SUNDRY NOTICES AND REPORTS ON WELLS

Apache # 16

Apache Corporation proposes to P&A this well in this manner:

## EXISTING WELLBORE DIAGRAM

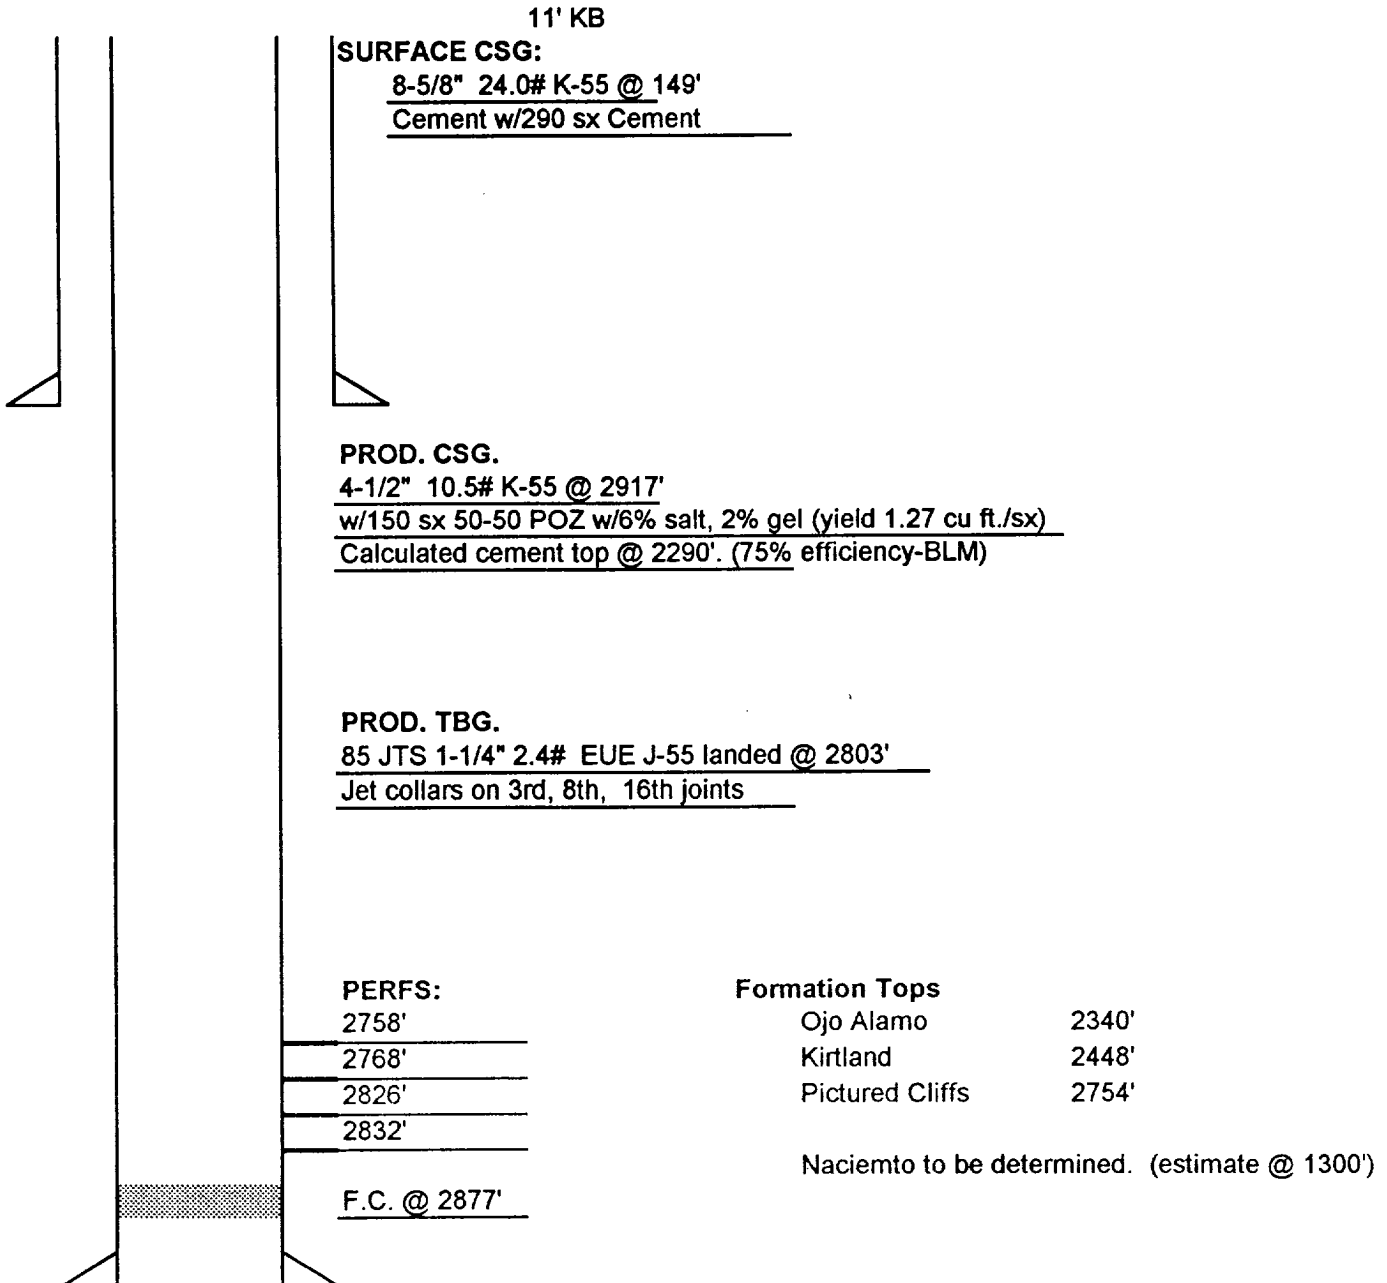
Attached / Surface Plg - 100 cf = 150 % P.C.
